Charlotte-Mecklenburg Planning Department

SUBJECT: Administrative Approval for Petition No. 1989-096 The Flad Mullinax Partnership

PROJECT NAME: U.S. FOODS - EASTWAY EXPANSION

U.S. FOODS

SITE AND LANDSCAPING

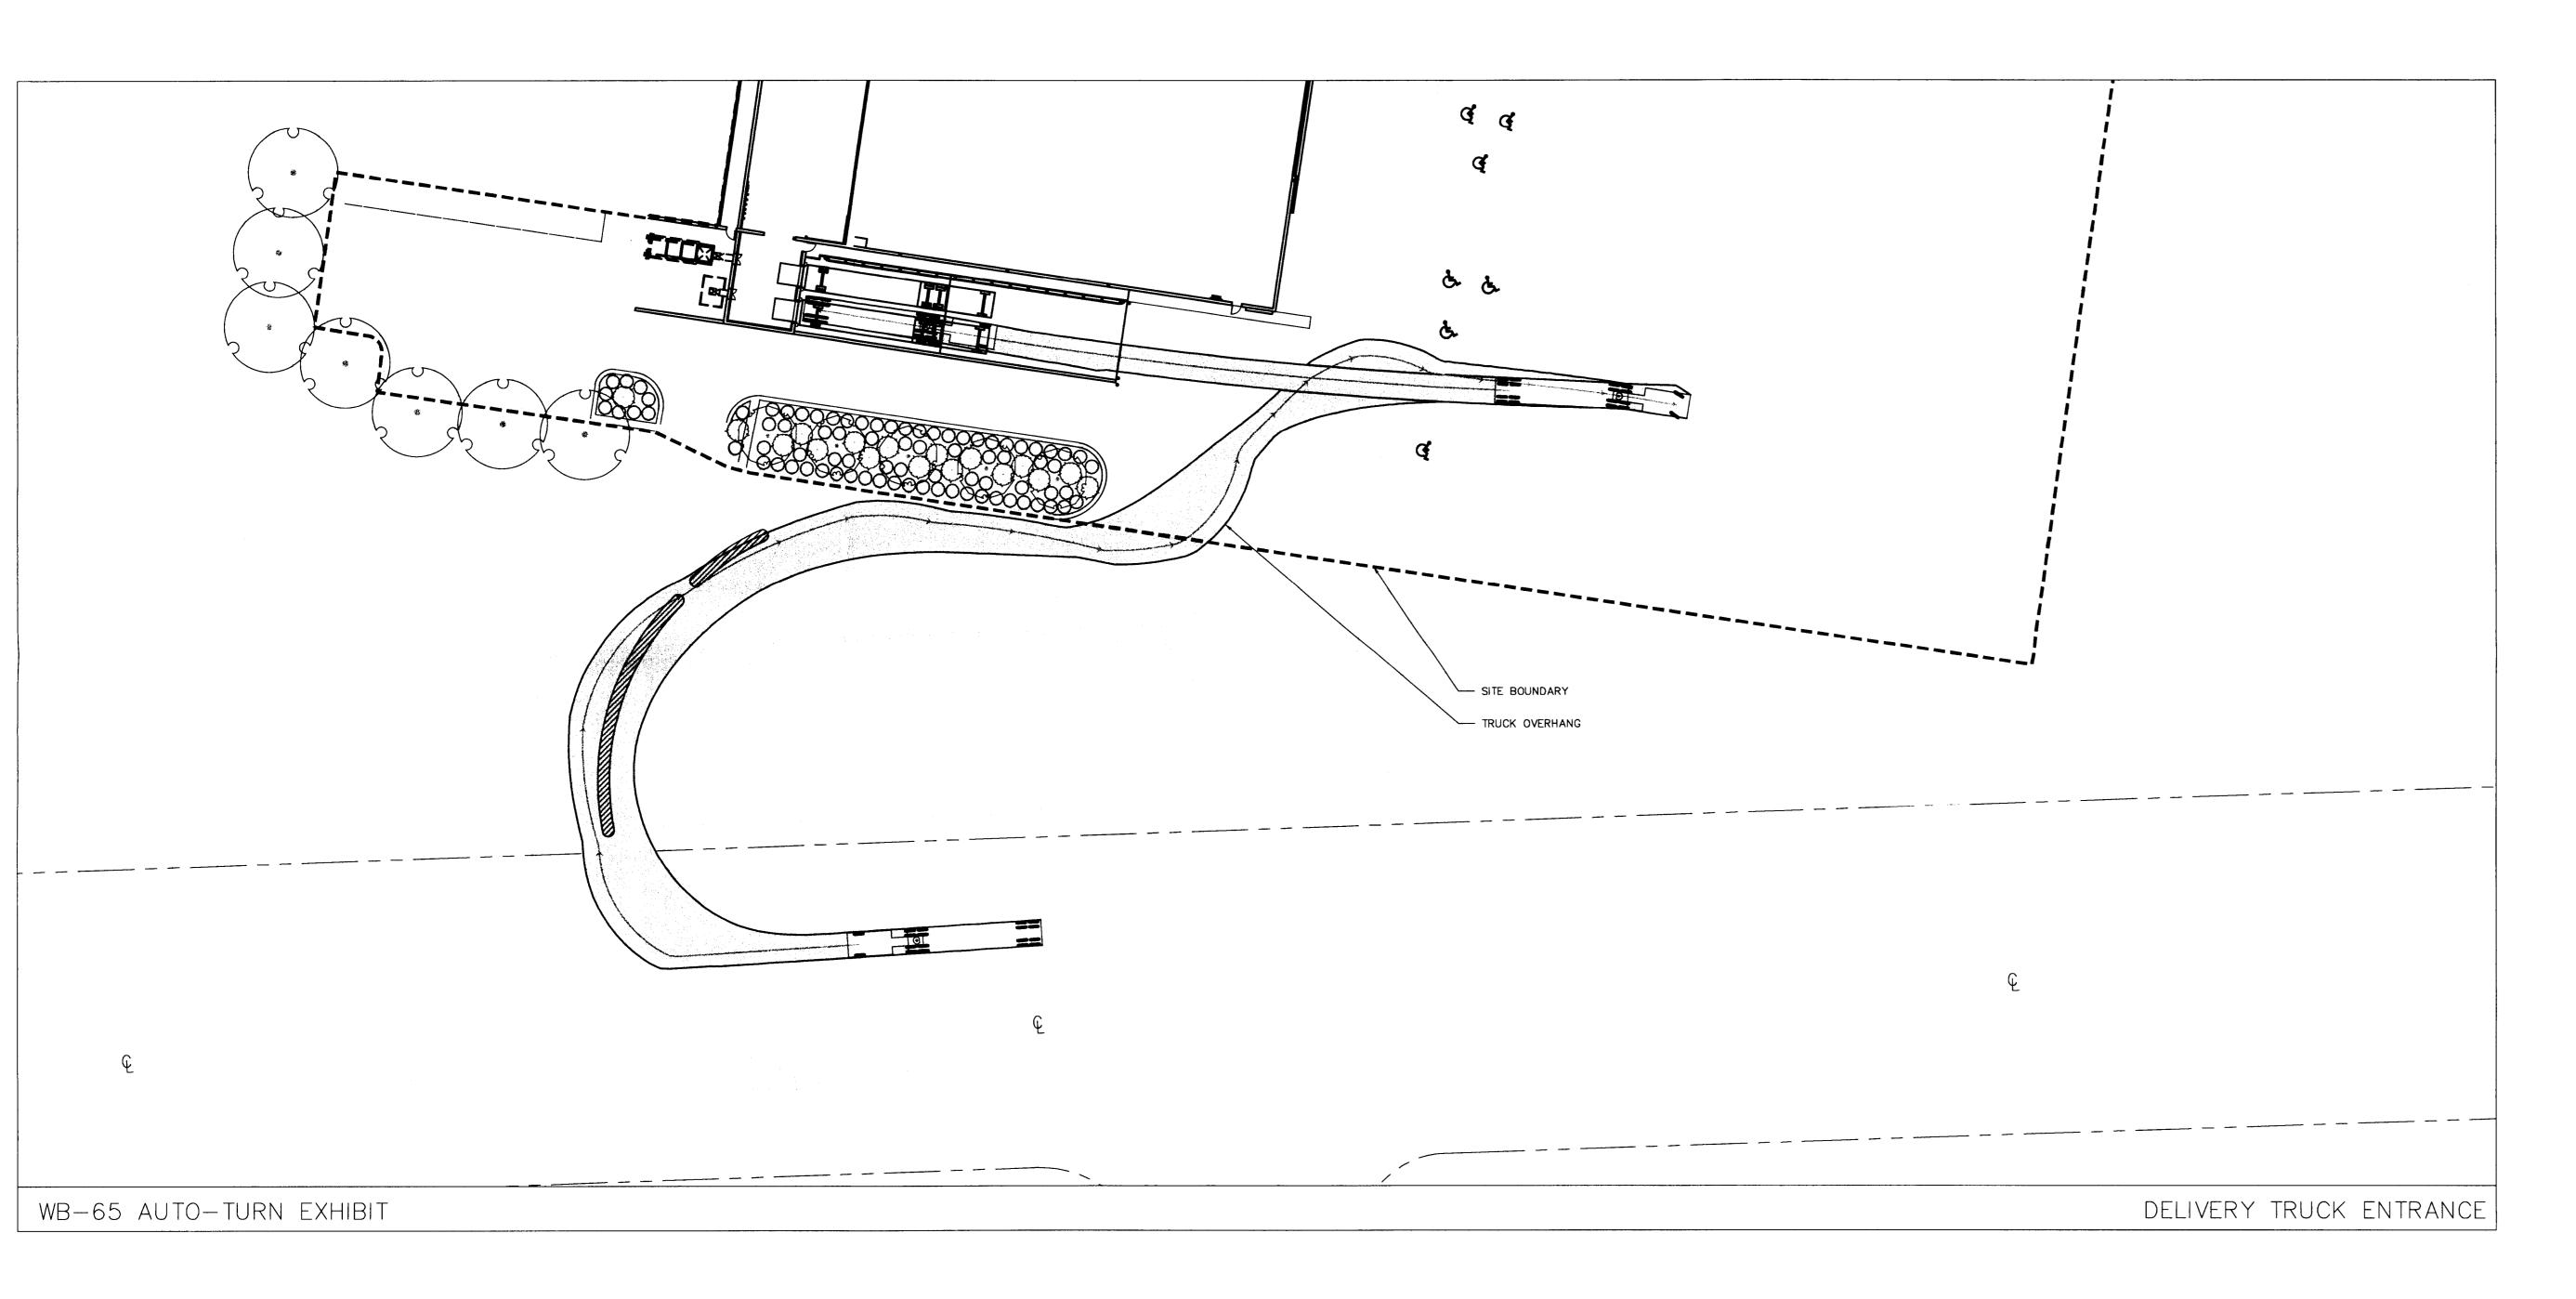
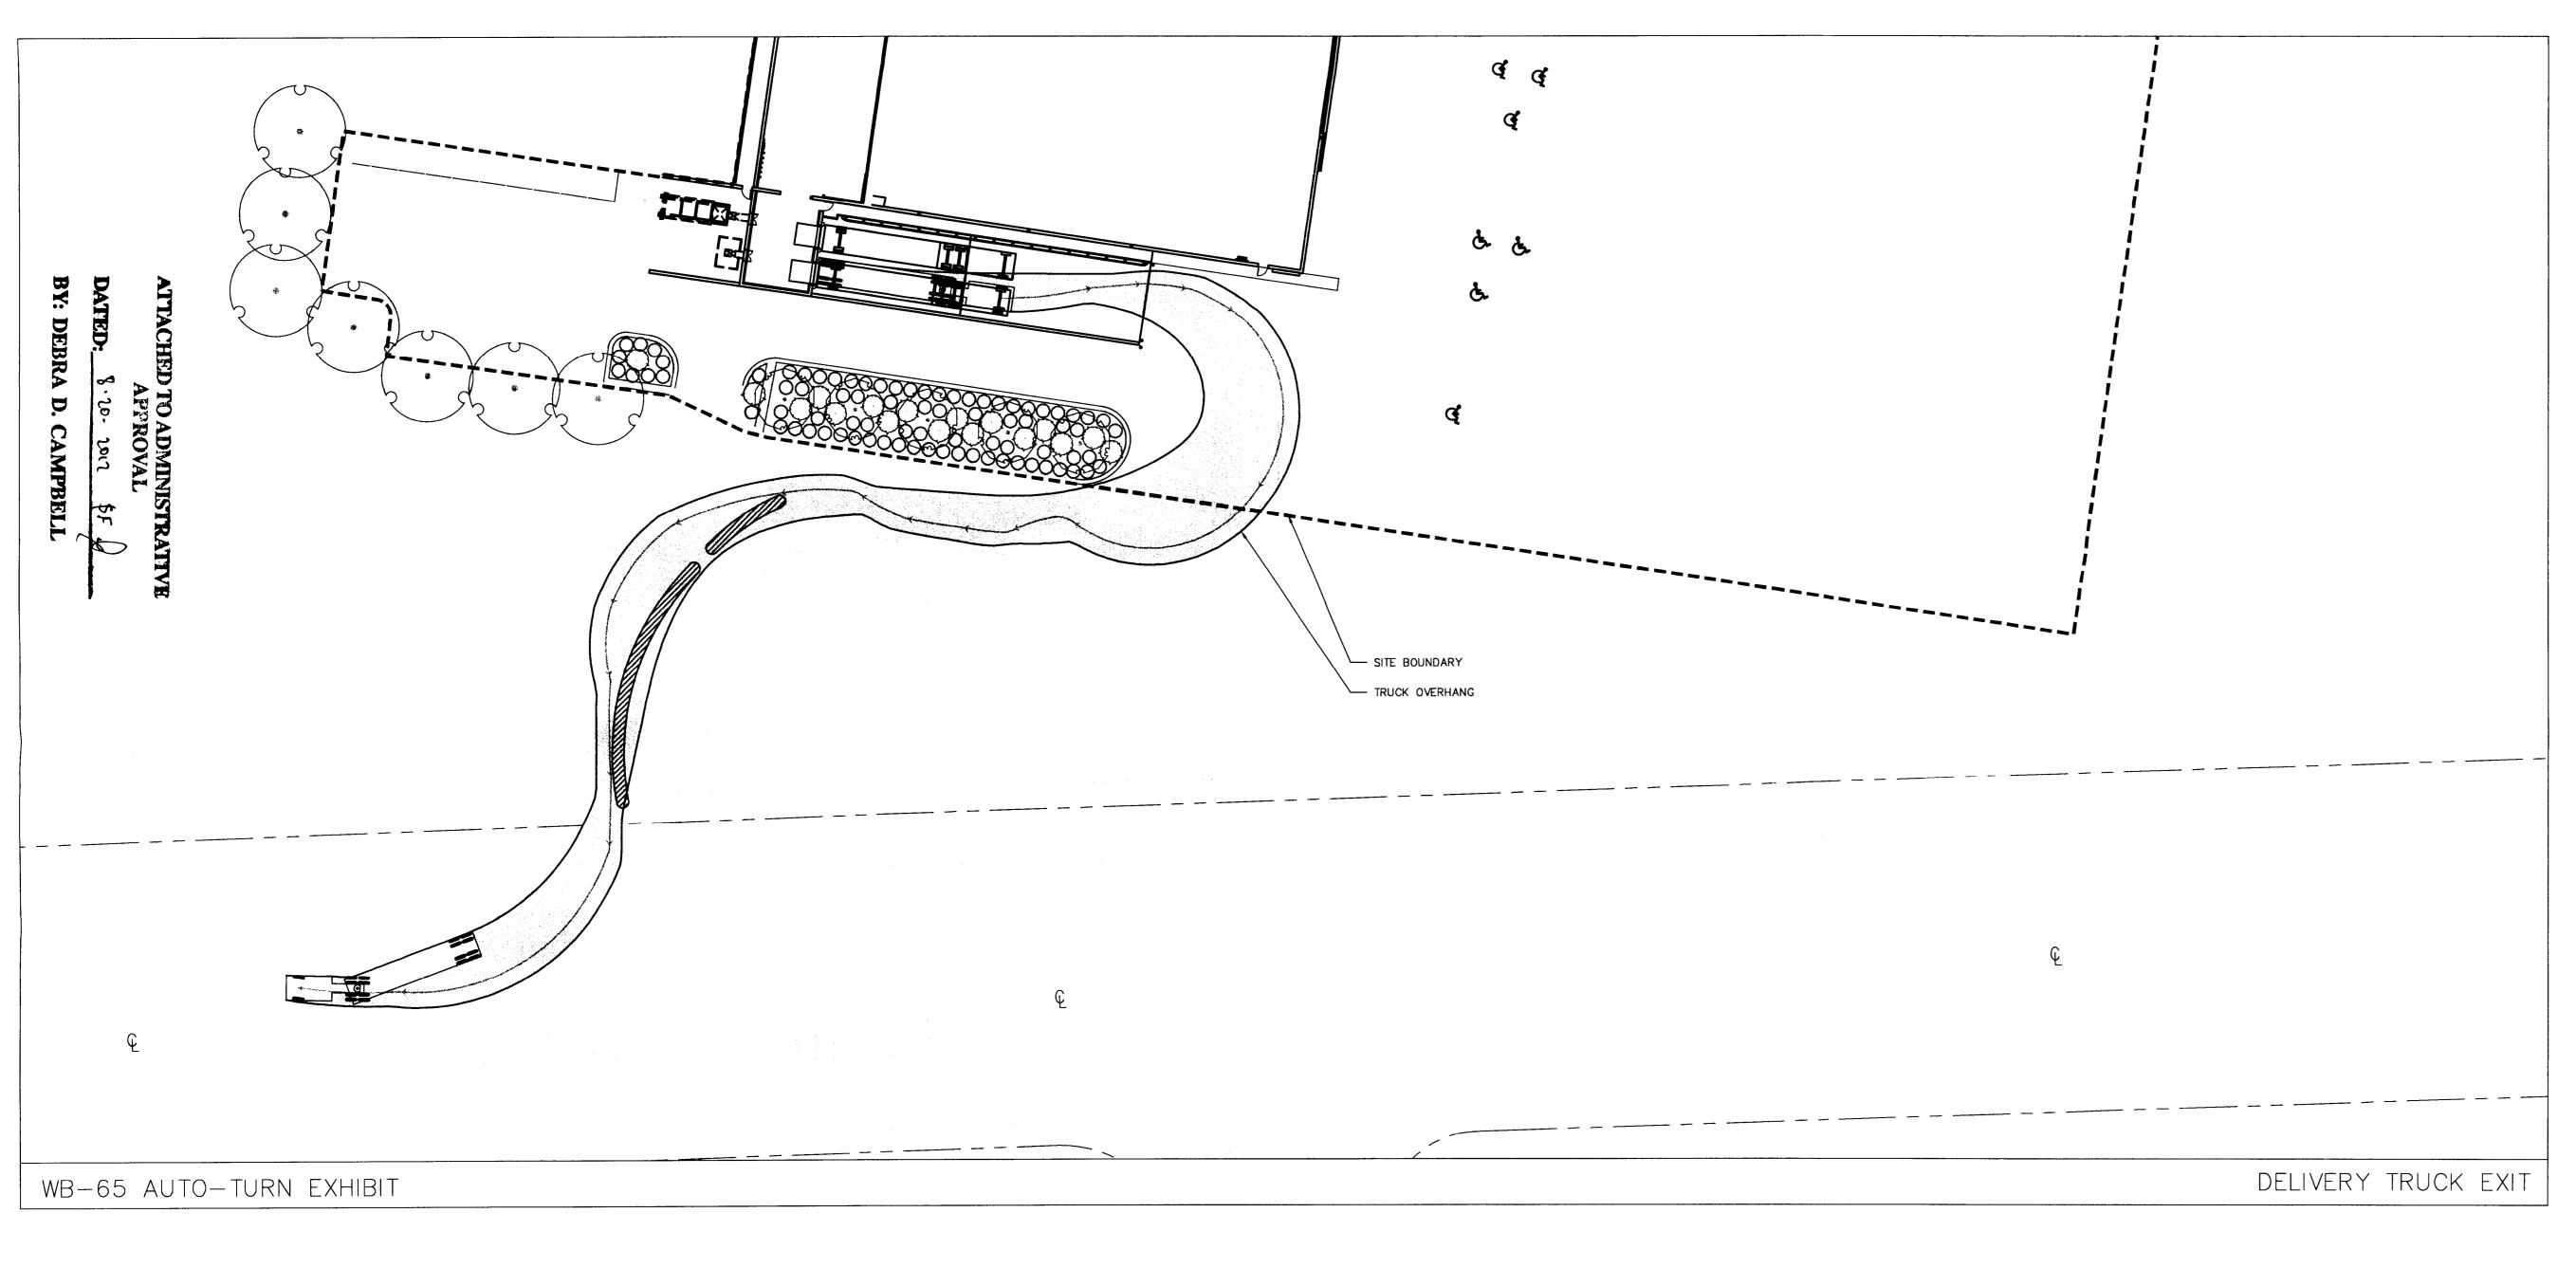
Attached is a revised site plan for the above referenced rezoning petition. The site plan shows modifications for a load dock for the vacant Wal-Mart Building. The drawings show a five foot screen wall and plantings to screen the loading dock from Eastway Drive. Since this change does not alter the intent of the development and meets the requirements of the Charlotte Zoning Ordinance Section 6.207 Alterations to Approval, minor changes, I am administratively approving this plan. Please use
